**OPERATIONS & MAINTENANCE COMMITTEE AGENDA**

To:	Howard Cin East Bay Dischargers Authority	Date:	October 6, 2023
From:	Dave Mathy DCM Consulting, Inc.	File:	No. 406
Subject:	Bandwidth IG, Fiber Optics Cable Project Bundled Conduit Installation by HDD at East Bay Dischargers Authority (EBDA) Marina Dechlorination Facility and 96-inch Outfall Pipeline San Leandro, California

This technical memorandum presents the results of a geotechnical and trenchless engineering review of currently available project information for Bandwidth IG’s planned fiber optics cable conduit installation by horizontal directional drilling (HDD) with respect to potential impacts on EBDA facilities. The Bandwidth IG project includes fiber optics cable installation across San Francisco Bay from Brisbane (western landing) to San Leandro (eastern landing). The eastern landing includes a segment (Span 1C, Segment 012) located in the Marina Park area of San Leandro that crosses EBDA’s 96-inch Outfall Pipeline. The approximate alignment of Span 1C, Segment 012 is shown in Figure A along with the location of EBDA’s Marina Dechlorination Facility and 96-inch Outfall Pipeline to San Francisco Bay.

**Original Bandwidth Infrastructure Group Project Plans**

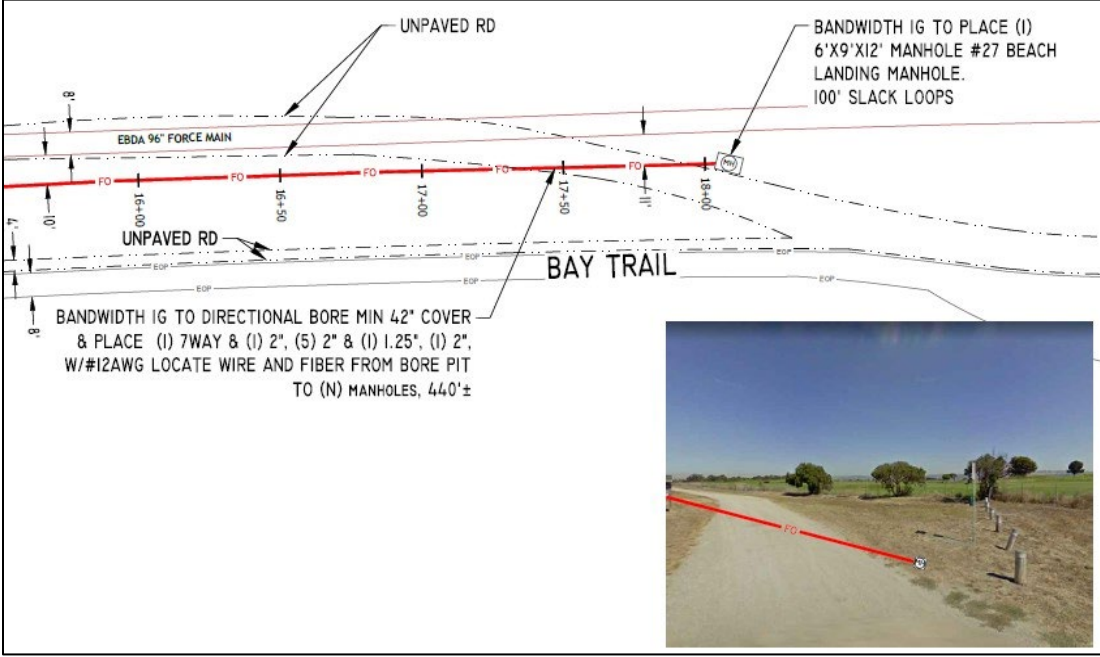
These plans have the EBDA 96-inch force main in the wrong location resulting in the Bandwidth manhole directly on top of the EBDA force main.

These plans have the EBDA 96-inch force main in the correct location. The force main and the fiber line in red switched positions, which eliminated the fiber line crossing the EBDA force main in this location.

**Figure 1** – Excerpt from EBDA record drawings for the 96-inch Outfall Pipeline, Drawing No. 4. The Marina Dechlorination Facility to the left and the 96-inch Outfall Pipeline Flow Meter and Meter Box to the right. The length of the 96-inch Outfall Pipeline between the two structures is 95.5 feet.

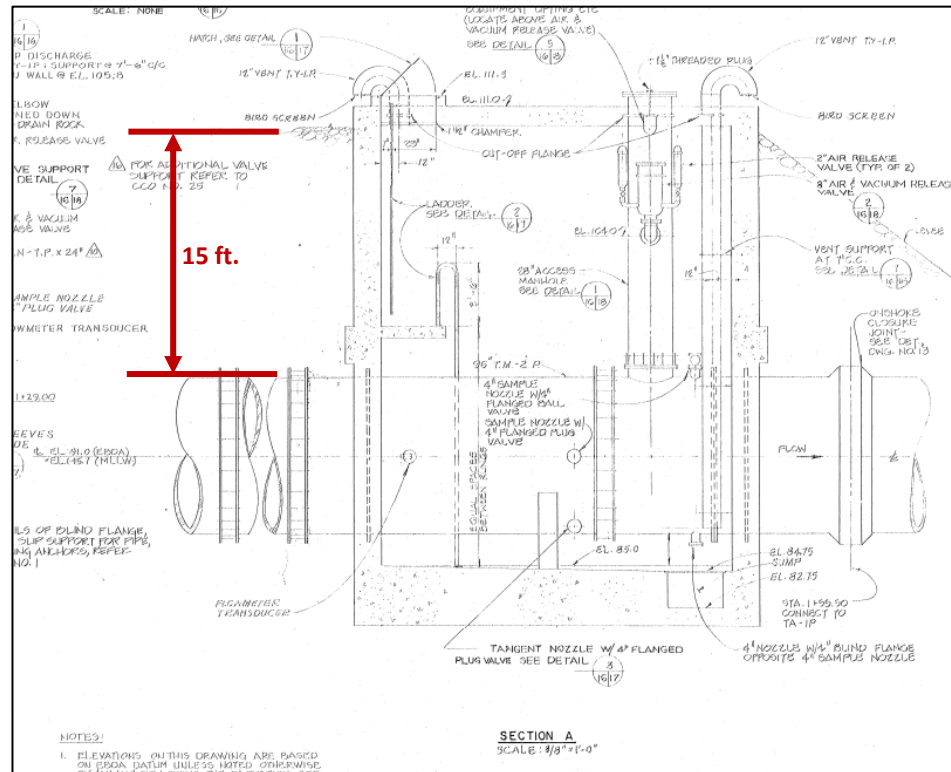
Note the plan view location of 2-inch electrical and instrumentation conduits and 1-½ to 2-inch PVC sample lines between the Dechlorination Facility and Flow Meter and Meter Box. All conduits and pipes between the Dechlorination Facility and Flow Meter and Meter Box must be fully accounted for and potholed for accurate location and depth for HDD bore path design (see Figure 3).

5. Every electrical and instrumentation conduit and PVC sample line between the Marina Dechlorination Facility and the 96-inch Outfall Flow Meter and Meter Box (see Figure 1) must be:

- a. accounted for;
  - b. potholed; and
  - c. accurately located.

Once accurately located the HDD bore path must maintain a minimum of 5 feet of clearance from each conduit as well as 5 feet of clearance from the 96-inch Outfall Pipeline and with a minimum of 6 feet of cover (for a 12-to-14-inch reamed bore hole diameter).

**Figure 2** – The depth of cover on the 96-inch Outfall Pipeline from record drawings varies from 13 feet at the Marina Dechlorination Facility (upper section) to 15 feet at the Flow Meter/Meter Box (lower section). Depth of cover at crossing to be confirmed by potholing.

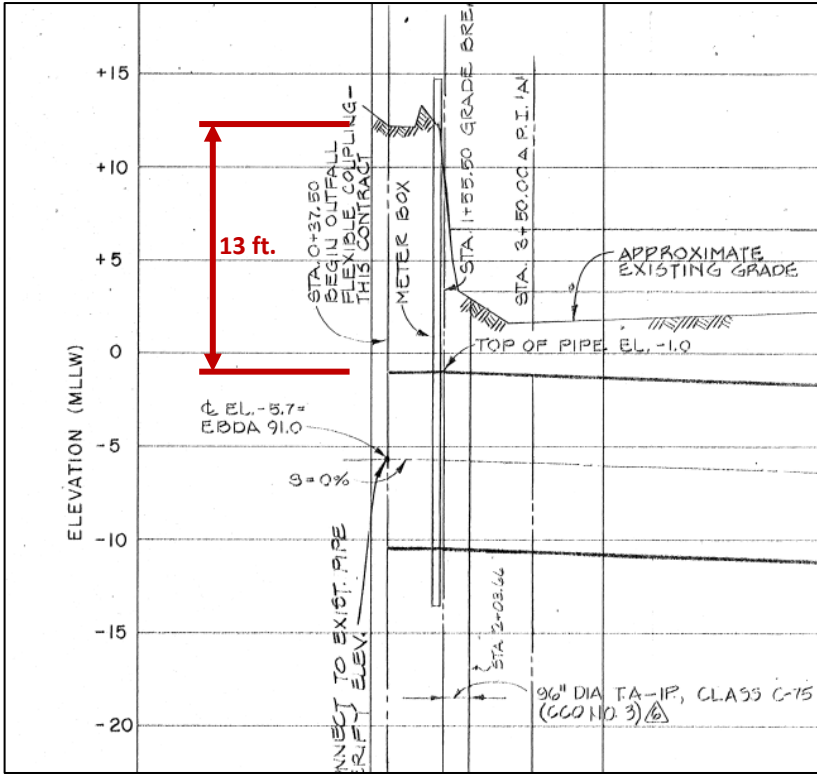
2. Where the Bandwidth IG fiber optic conduits cross EBDA's 96-inch Outfall Pipeline (approximately Bandwidth IG Station 5+05) the ground surface is paved and the top of the 96-inch Outfall Pipeline is approximately 13 to 15 feet below ground surface (see Figure 2 for excerpts from EBDA record Outfall Pipeline drawings). Within the 13 to 15 feet of cover, there are multiple 2-inch electrical and instrumentation conduits and 1-½ to 2-inch PVC sample lines connecting the Marina Dechlorination Facility and 96-inch Outfall Pipeline Flow Meter and Meter Box (see Figure 1).

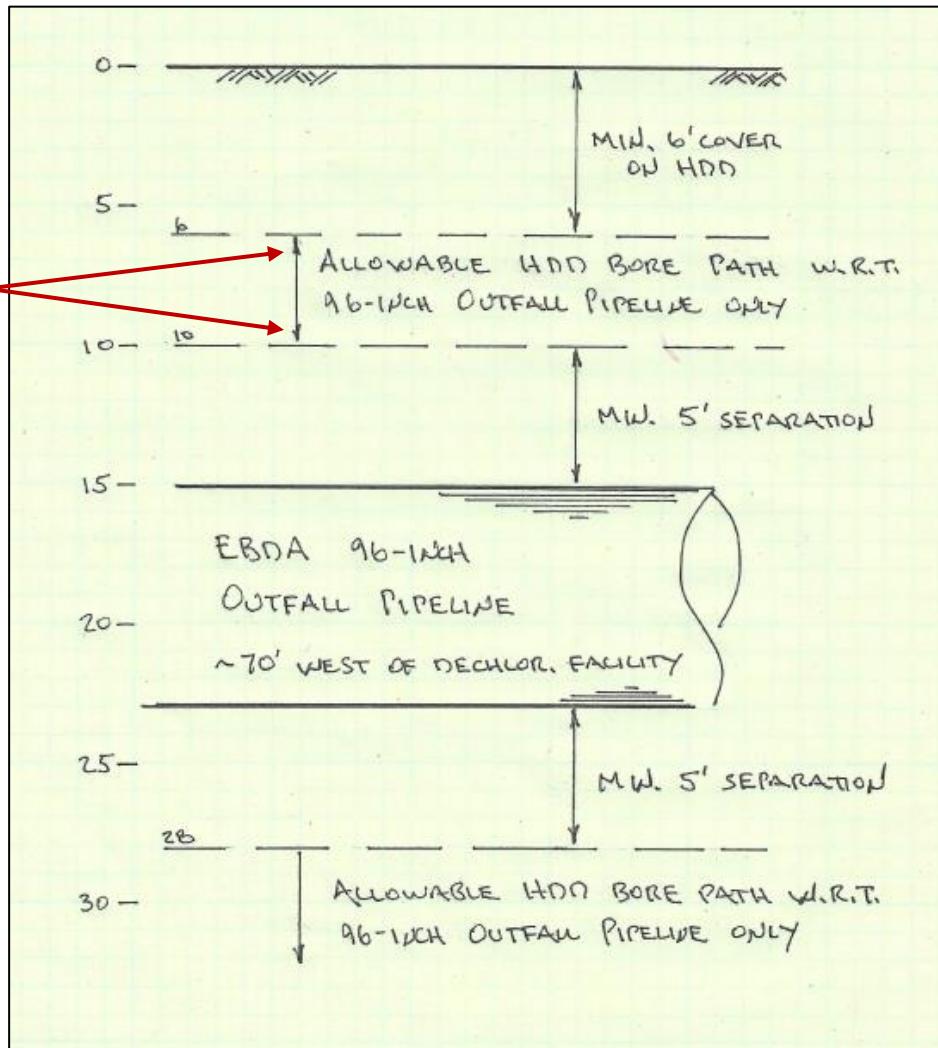
As shown in Figure 3, the available HDD bore path above the 96-inch Outfall Pipeline is very limited with respect to the 96-inch Outfall Pipeline only. When the multiple 2 inch electrical and instrumentation conduits and 1-½ to 2-inch PVC sample lines are fully accounted for and pot holed for accurate depths they will need to be added to this or similar section. Given the minimum depths of cover and minimum clearances from crossing utilities specified in Bandwidth IG's plans Construction Note 5 (see Figure B), it may be impossible to directional drill above the 96-inch Outfall Pipeline. Bandwidth IG should provide a bore profile for final review (similar to sheet BP-1 for the A.C.F.C. Creek crossing) for crossing EBDA's 96-inch Outfall Pipeline and associated 2-inch electrical and instrumentation conduits and 1-½ to 2-inch PVC sample lines.

Note that this schematic section does not include the depths of multiple electrical and instrumentation conduits and PVC sample lines between the Dechlorination Facility and 96-inch Outfall Pipeline Flow Meter/Meter Box as shown in Figure 1. Once accurately accounted for and located these conduits need to be added to this evaluation of allowable HDD bore path depth.
